Re: **PETITION NO. 1612** – TRITEC Americas, LLC notice of election to waive exclusion from Connecticut Siting Council jurisdiction, pursuant to Connecticut General Statutes §16-50k(e), and petition for a declaratory ruling, pursuant to Connecticut General Statutes §4-176 and §16-50k, for the proposed construction, maintenance and operation of a 0.999-megawatt AC solar photovoltaic electric generating facility located at 37 Hunters Lane, Southington, Connecticut, and associated electrical interconnection. **Petitioner Response to Council Interrogatories.**

**Petition No. 1612
TRITEC Americas, LLC
37 Hunters Lane, Southington, Connecticut**

**Interrogatories
April 22, 2024**

Sheet Title:	Sheet #:
SOIL EROSION & SEDIMENT CONTROL PLAN PHASE I	2.31

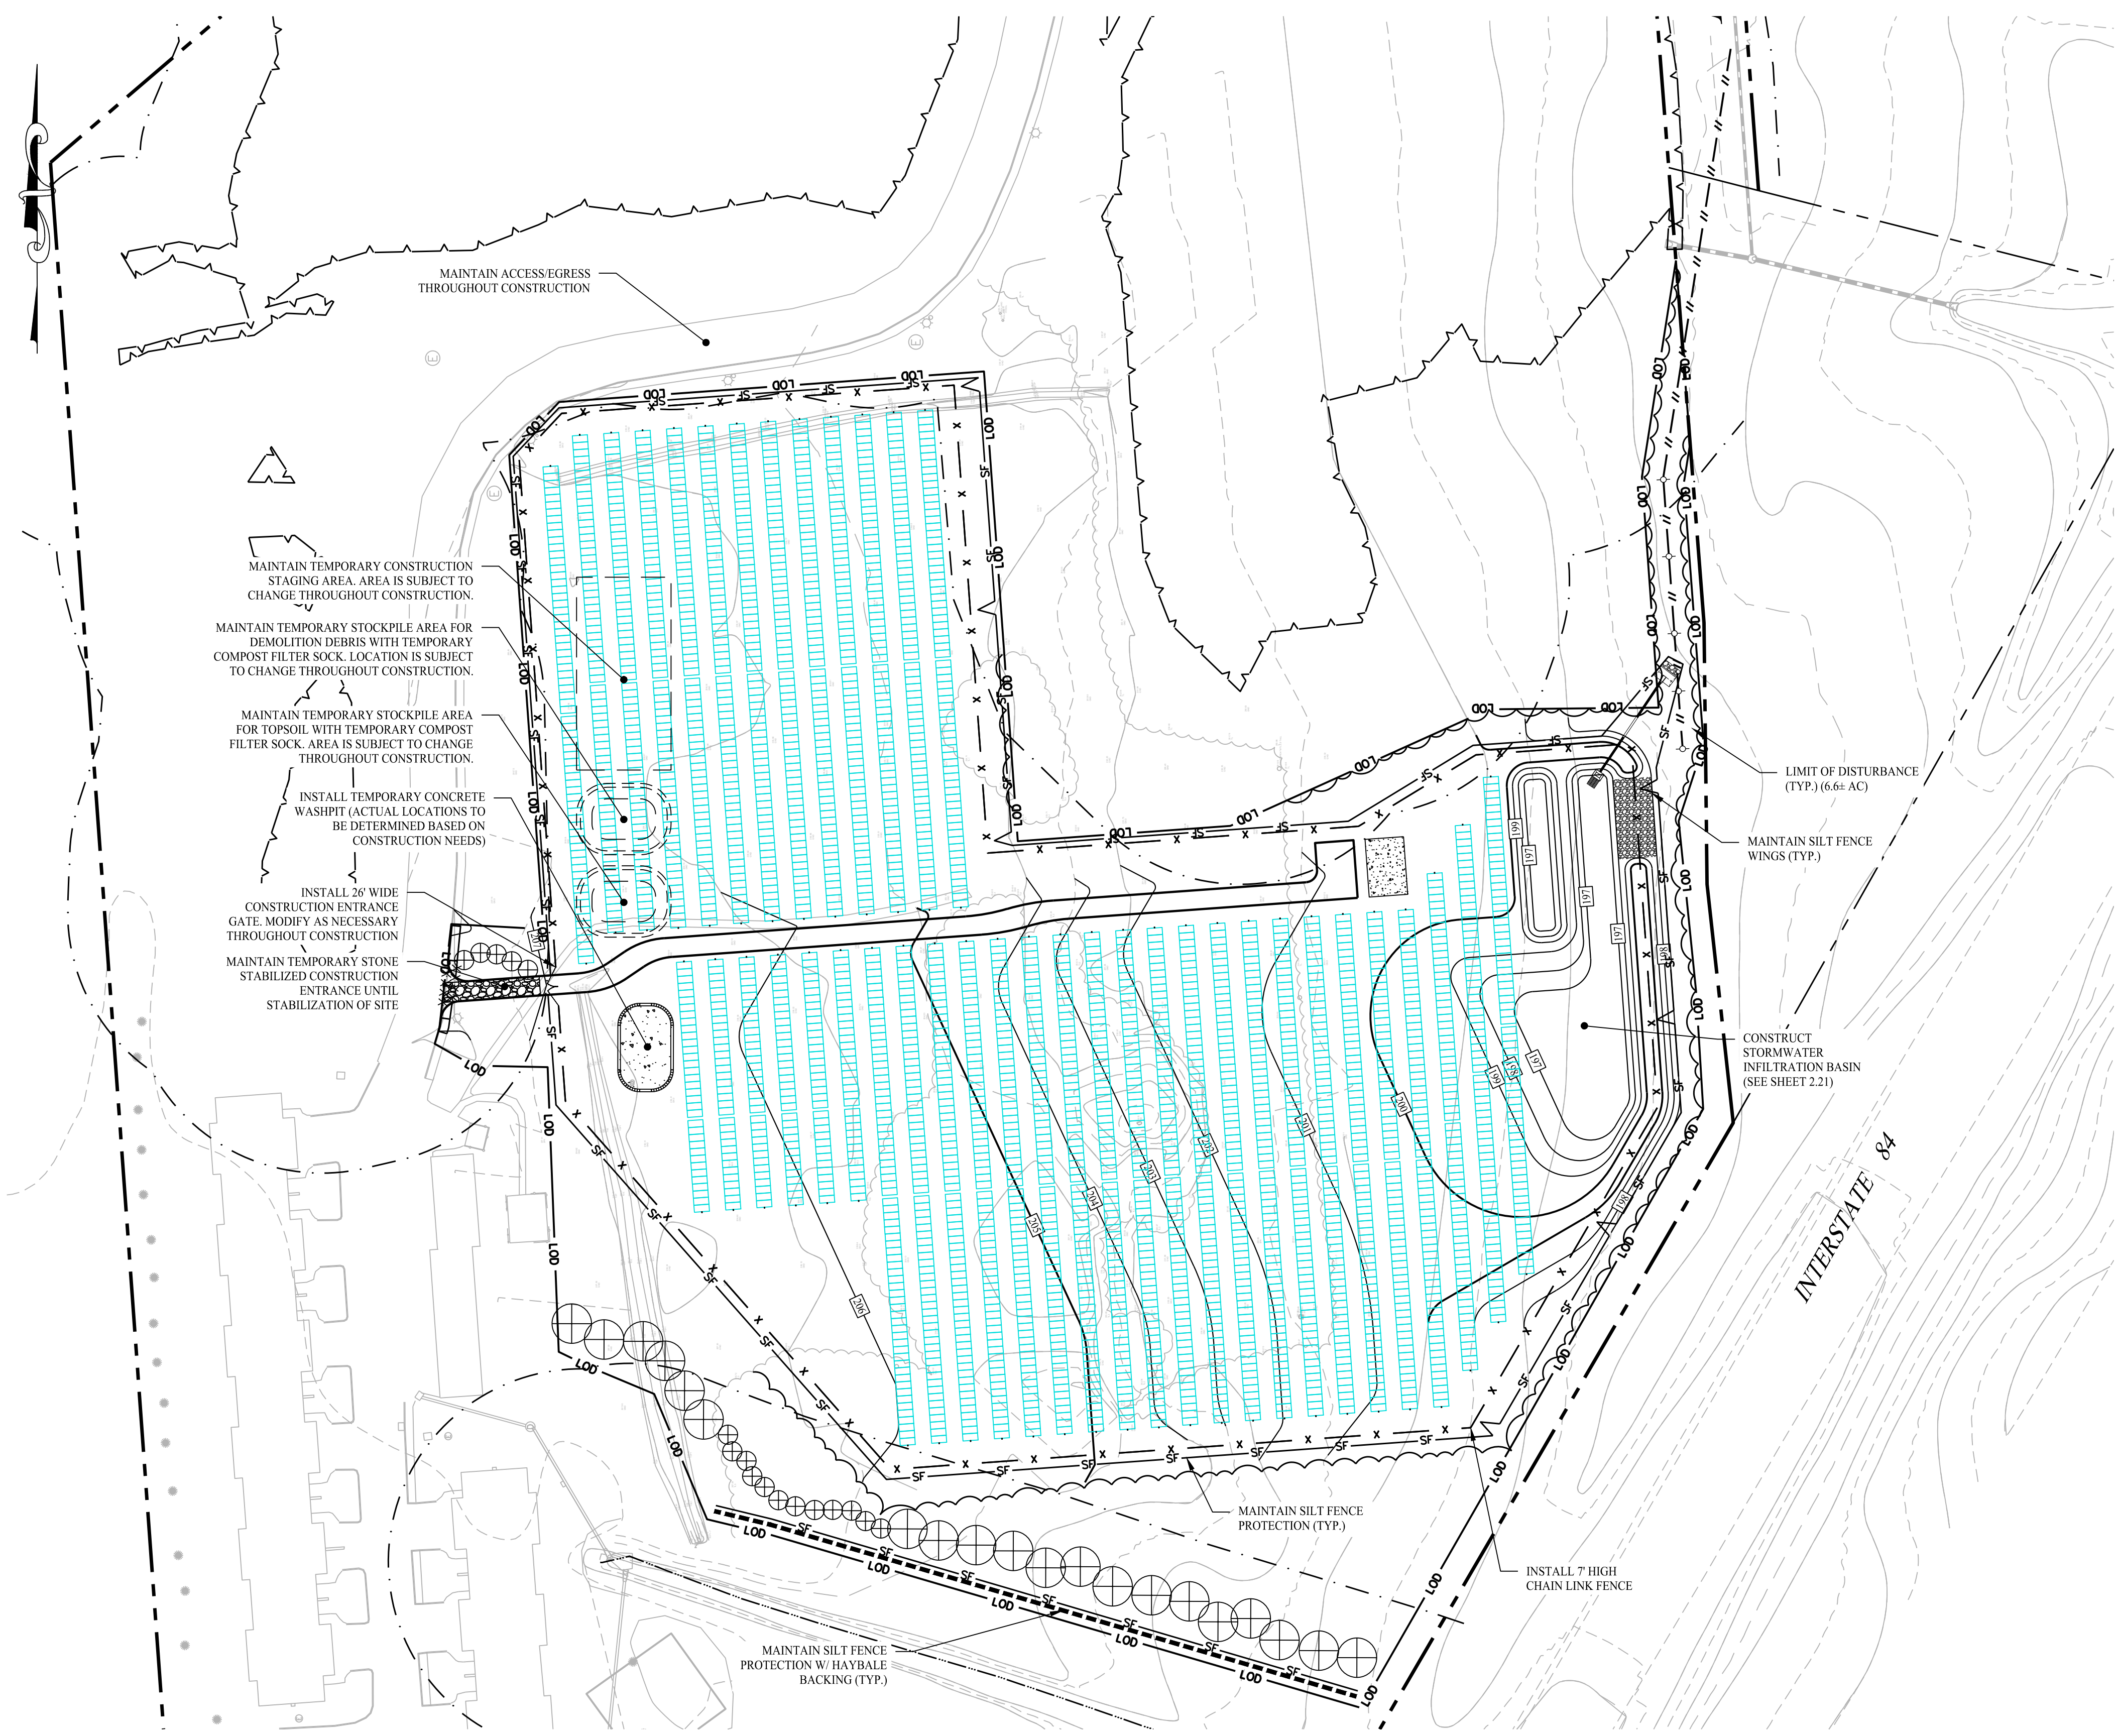
33. Referencing Petition Appendix B, Site Plan 2.31 a culvert is shown at the edge of the limit of disturbance associated with the underground electrical line in the northeast corner of the host parcel. Is a culvert inlet or outlet structure shown at the demarcation of the limit of disturbance? How will the installation of the underground electric line with a trench affect above ground, and underground, water flow in the culvert area?

48. Referencing Petition Site Plan 2.31, Note 1, is the preliminary design of the Project at least 50 percent complete? If not, would construction comply with the Connecticut Soil Erosion and Sediment Control Guidelines and Connecticut Stormwater Quality Manual, effective March 30, 2024?

The design complies with the Connecticut Soil Erosion and Sediment Control Guidelines and Connecticut Stormwater Quality Manual, effective March 30, 2024. Petition Site Plan 2.31, Note 1 has been revised accordingly. Please see “Exhibit B: Revised Civil Plan Drawing Set.”

A construction staging area has been identified on Sheets 2.31 and 2.32. Please see “Exhibit B: Revised Civil Plan Drawing Set.”

7' HIGH CHAIN LINK FENCE DETAIL

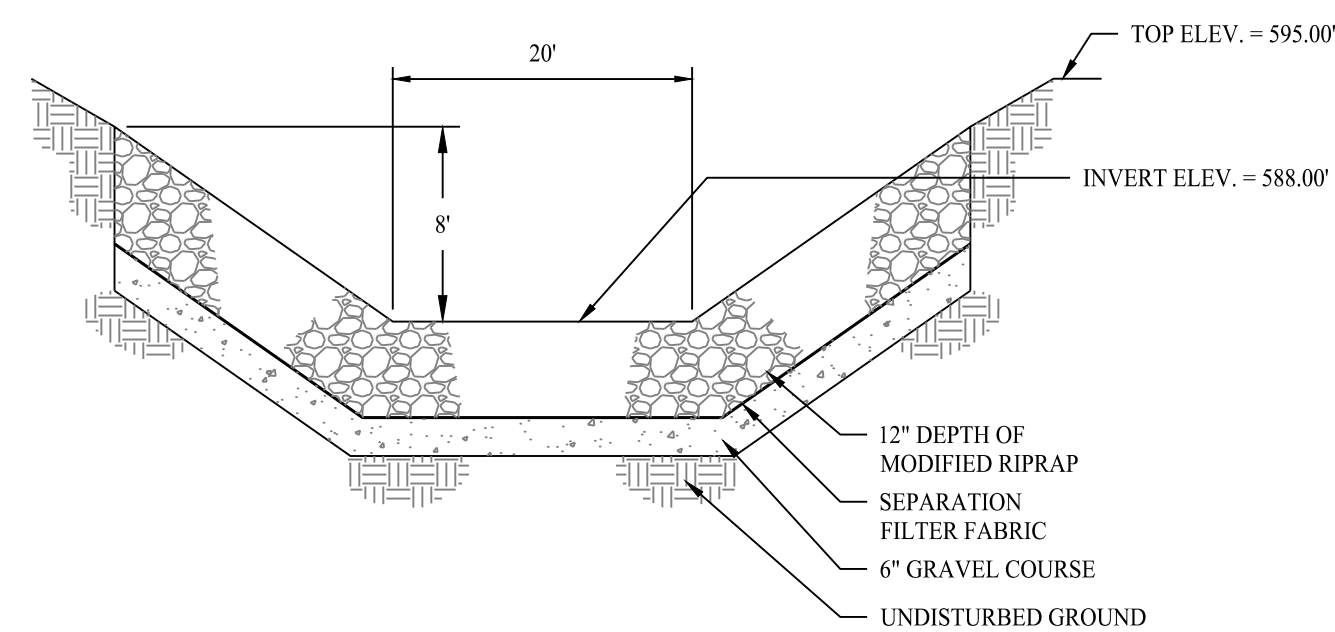
49. Referencing Petition Site Plan 3.01- Fence Detail, can the bottom of the perimeter fence fabric be raised to a height of six-inches above grade to allow for small wildlife movement?

Petitioner revised the detail accordingly to provide a six-inch gap to allow for small wildlife movement. Please see “Exhibit B: Revised Civil Plan Drawing Set.”
